ERNEST JORDAN ADDITION

RE: SUB 2001-101 -- One-Step Final Plat of Ernest Jordan Addition

At the regular meeting of the Subdivision Committee of the Metropolitan Area Planning Commission on Thursday, October 18, the above captioned plat was considered. The action of the Committee was to approve the final plat, subject to the following:

CASE NUMBER: SUB 2001-101 -- ERNEST JORDAN ADDITION

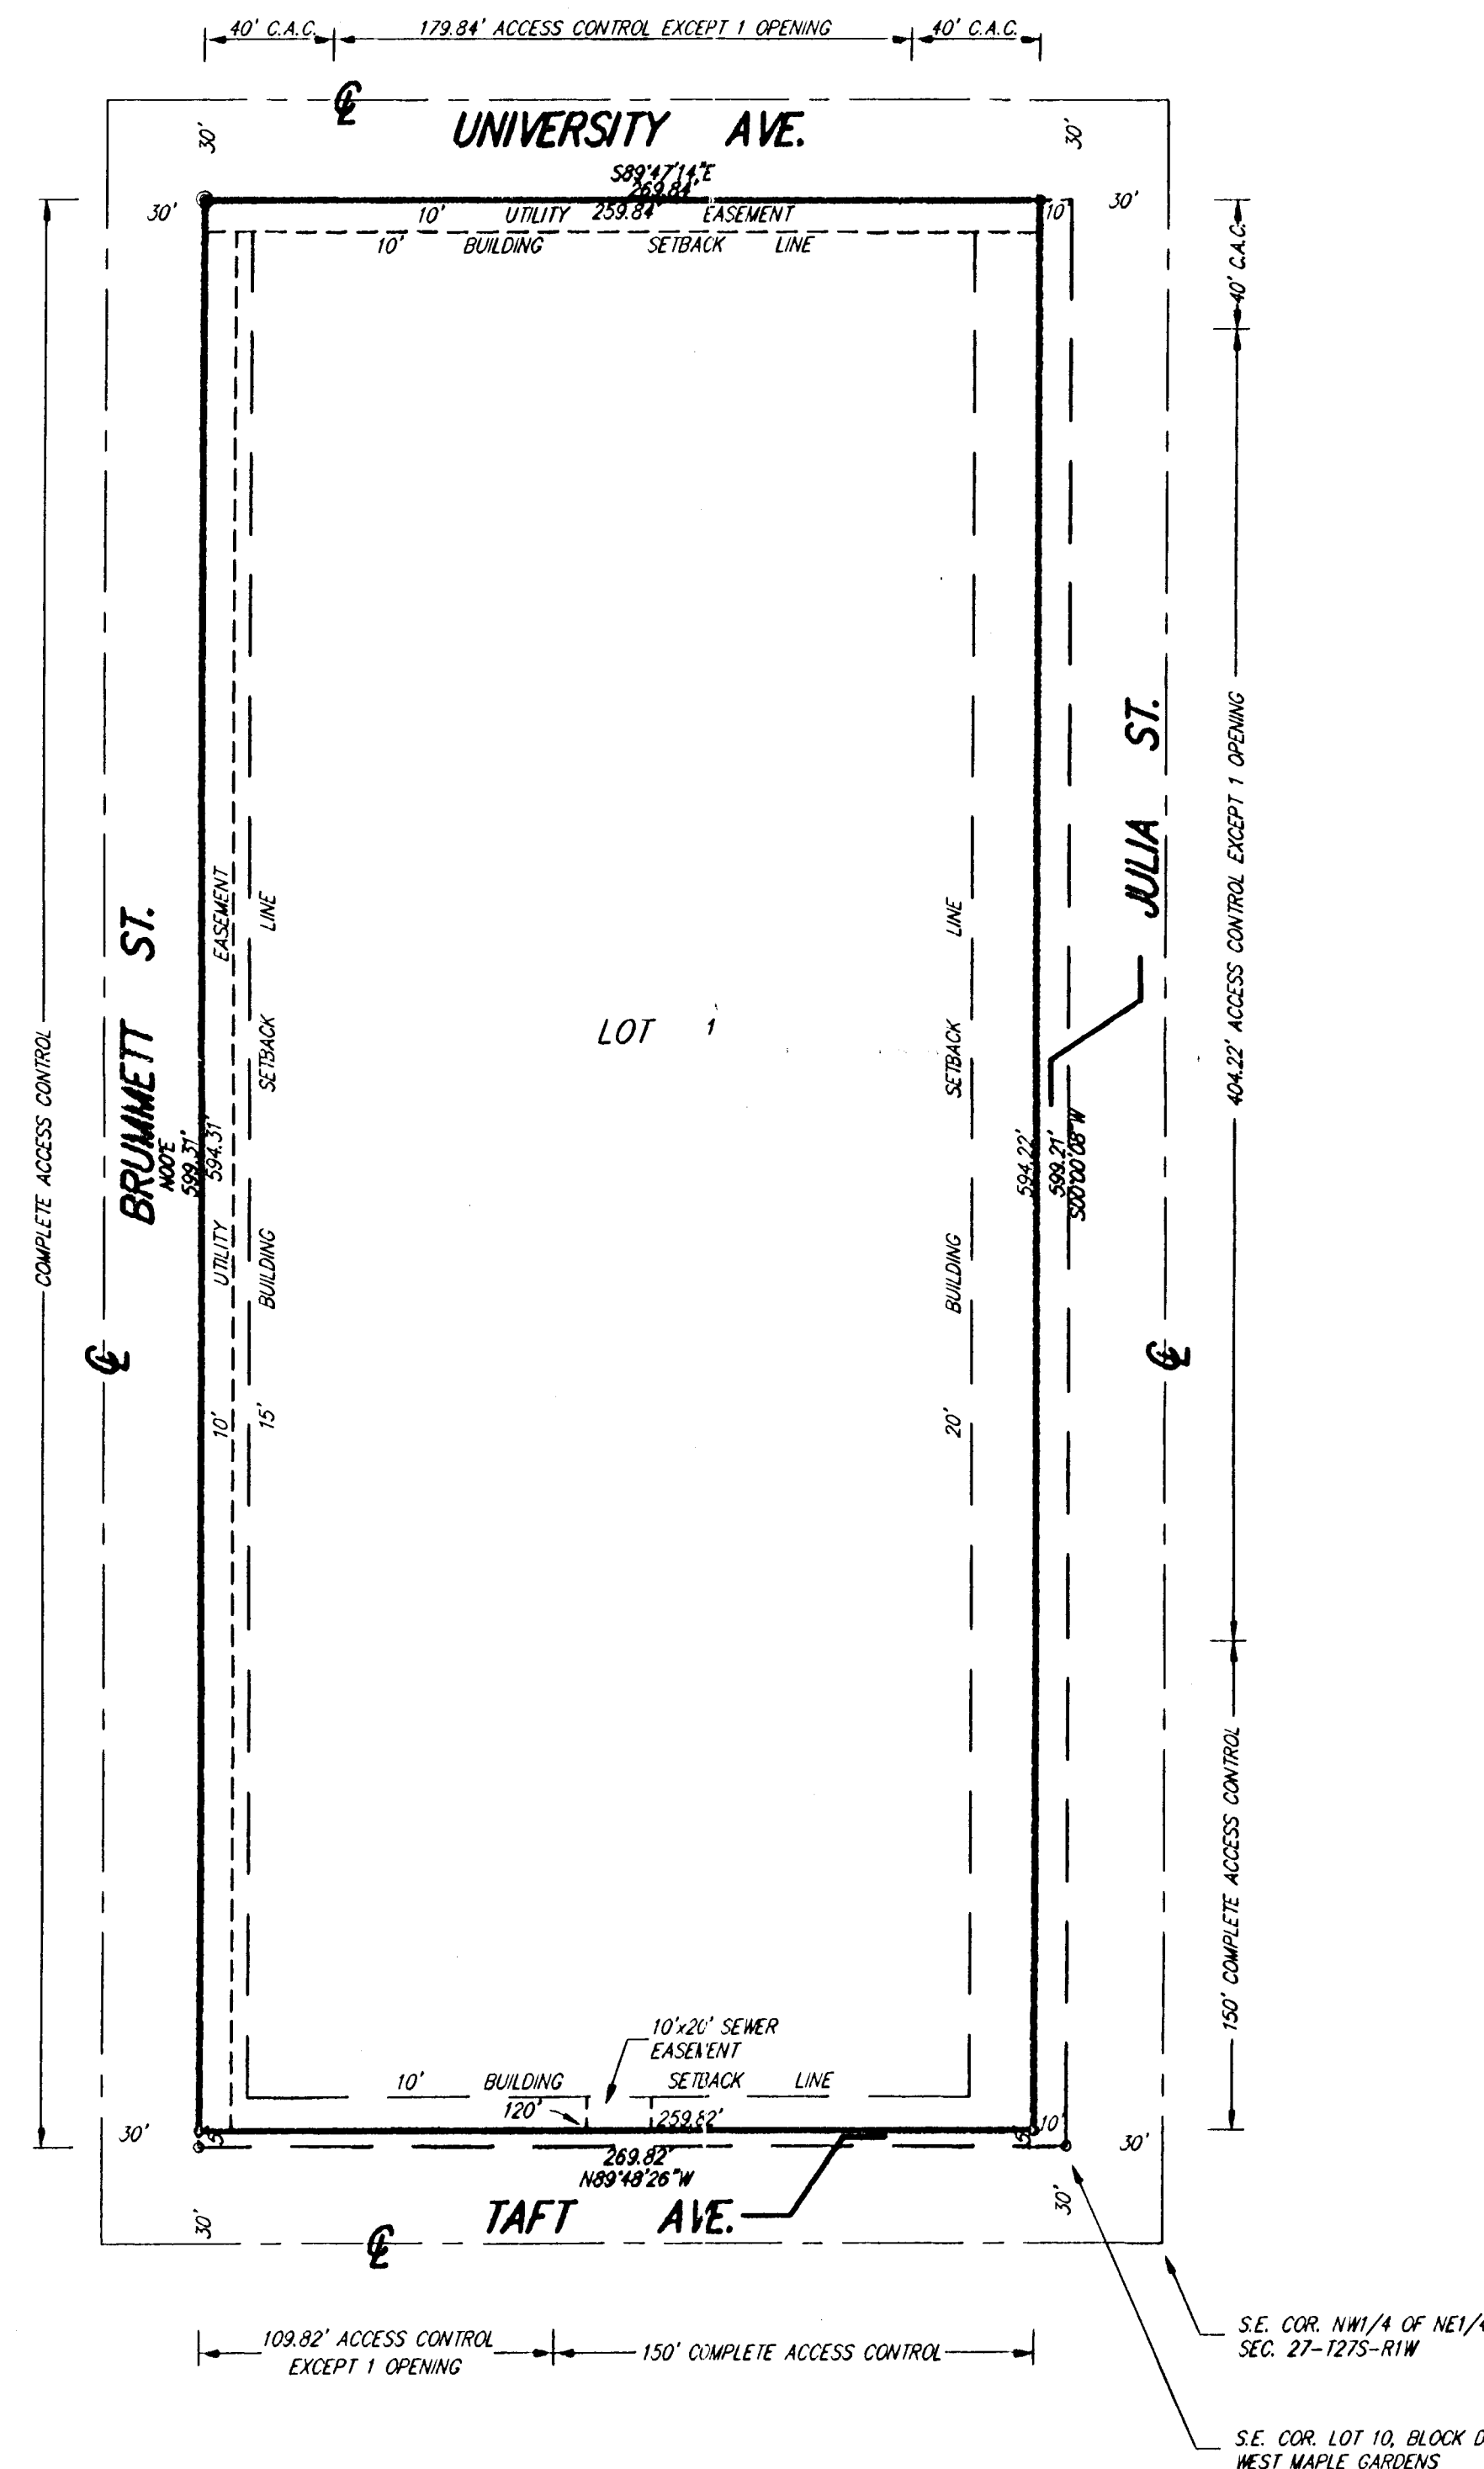
- A. City Engineering needs to comment on the need for guarantees or easements. The Applicant shall provide guarantees for sewer and water extension. A 10-ft utility easement is needed along the north property line.

- C. City Engineering needs to comment on the status of the applicant's drainage plan. *The drainage plan is approved.*
- D. Traffic Engineering needs to comment on the access controls. The plat proposes three access openings along Julia and one opening along Taft. Distances should be shown for all segments of access control. *Traffic Engineering and MAPD recommend one opening along both Julia and Taft, with 150 feet of complete access control from the intersection of Taft and Julia.*

- F. Traffic Engineering needs to comment on the need for additional right-of-way for Taft or Julia, both of which are designated as collectors. The plat's text shall note the dedication of the streets to and for the use of the public. *The applicant shall dedicate an additional 5 feet of right-of-way for Taft.*

- K. On the final plat, the MAPC signature block needs to reference "J.D. Michaelis, Chair".
- L. The setback along the west property line needs to be increased to 15 feet to conform with a screening condition of the Protective Overlay.

- V. The representatives from the utility companies should be prepared to comment on the need for any additional utility easements to be platted on this property. Southwestern Bell has requested additional easements.
